NEW BUILD SNAGGING SURVEY

29/01/2025

Example Snagging Survey

Room:
Living Area

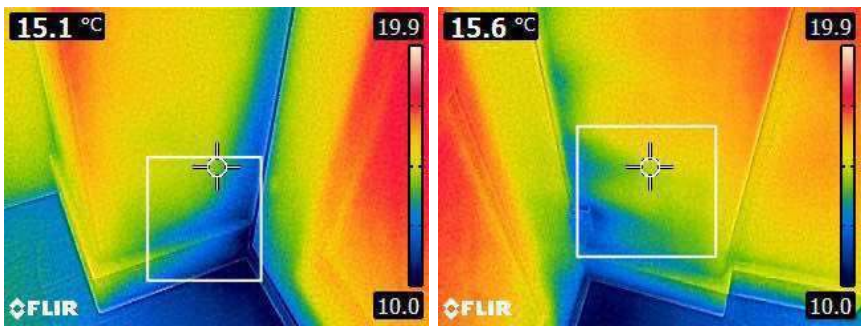
Thermal anomaly to the ceiling at the bay, likely caused by gaps in the insulation coverage or thermal bridging at the junction of the roof where poorly separated.

Room:
Dining Area

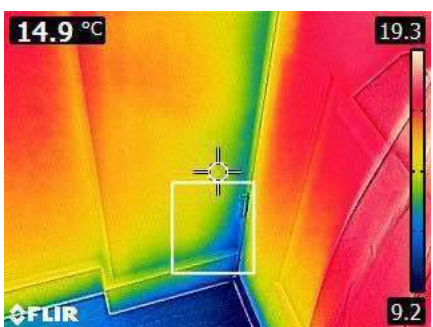
Thermal anomaly to the wall, which suggests a possible lack of cavity wall insulation.

Room:
WC

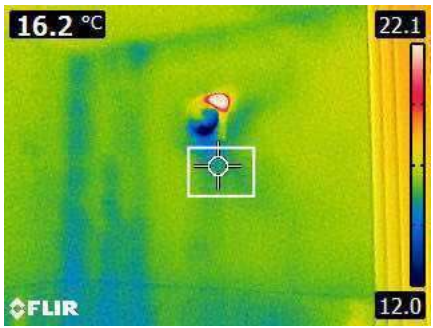
Thermal anomaly to the wall, which suggests a possible lack of cavity wall insulation.

Room:
Stairs / Landing

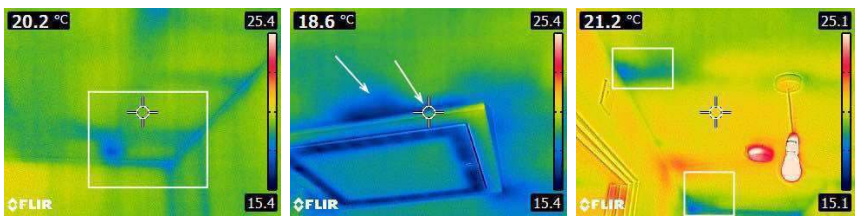
Thermal anomaly to the ceiling, which is caused by gaps in the loft insulation which will need to be fitted correctly.

Draughts around loft hatch, advise it is caulked

Room:
Bed 1

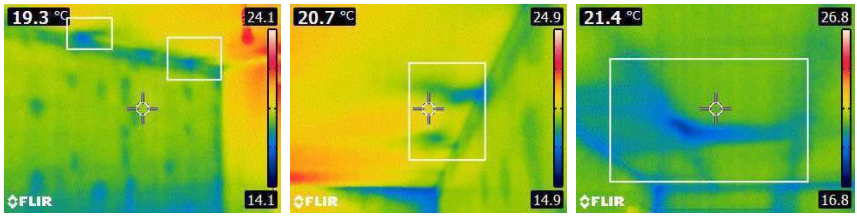
Thermal anomaly to the ceiling, which is caused by gaps in the loft insulation which will need to be fitted correctly., Thermal anomaly to the eaves, which is likely caused by missing or improperly laid insulation.

Room:
Ensuite 1

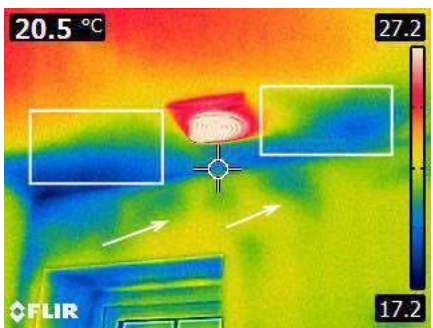
Thermal anomaly to the eaves, which is likely caused by missing or improperly laid insulation., Thermal anomaly to the plasterboard likely to be caused by air infiltration. This is usually caused by a lack of a continual ribbon of adhesive when dot and dab applied to the wall when installing the plasterboard sheets.

Room:
Bed 2

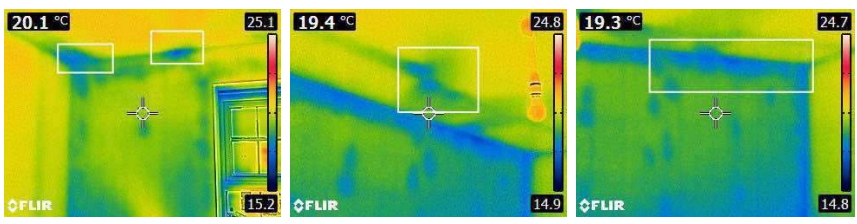
Thermal anomaly to the plasterboard likely to be caused by air infiltration. This is usually caused by a lack of a continual ribbon of adhesive when dot and dab applied to the wall when installing the plasterboard

sheets., Thermal anomaly to the ceiling, which is caused by gaps in the loft insulation which will need to be fitted correctly.

10 **Room:**
Bed 3

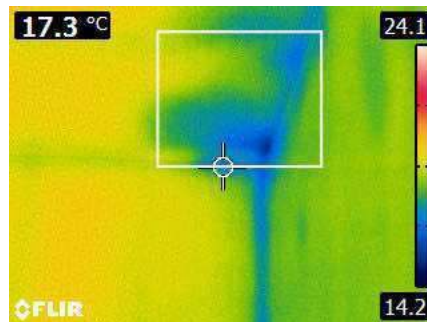
Thermal anomaly to the eaves, which is likely caused by missing or improperly laid insulation.

12 **Room:**
Bathroom 1

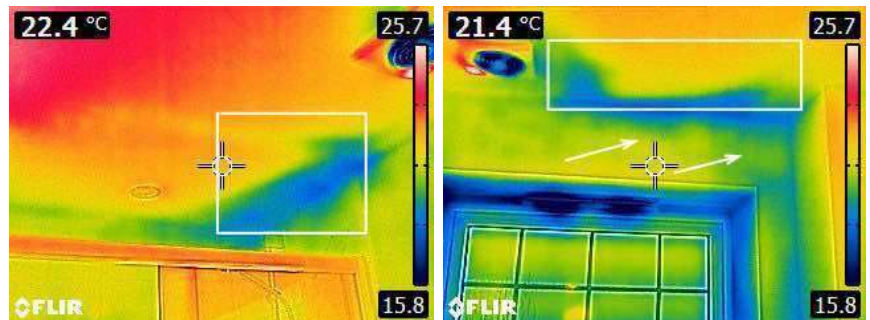
Thermal anomaly to the eaves, which is likely caused by missing or improperly laid insulation., Thermal anomaly to the plasterboard likely to be caused by air infiltration. This is usually caused by a lack of a continual ribbon of adhesive when dot and dab applied to the wall when installing the plasterboard sheets.

NHBC 9.1.3 Wall not flat

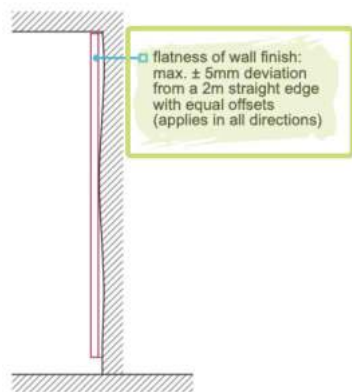
Shrinkage cracks which are caused by materials drying out and can be caused by differential movement between materials, which likely just need minor decorative repair. Should these increase in size beyond 3mm, further investigation may be required.

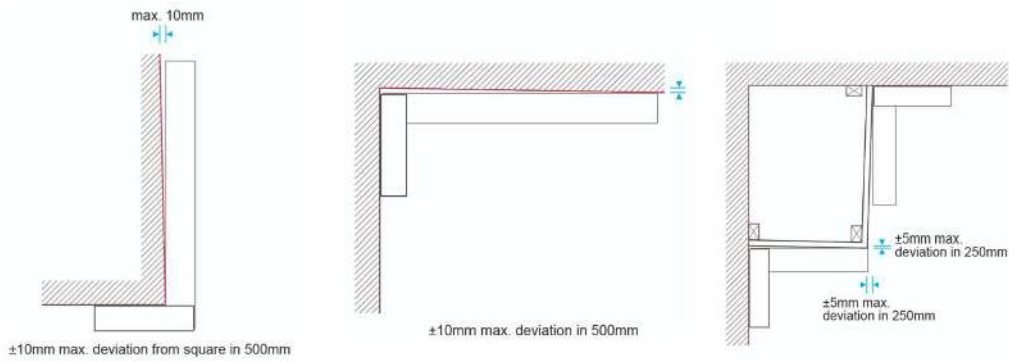
The patio doors ideally should have restrictors fitted so that the doors are kept from swinging open wider than 90 degrees
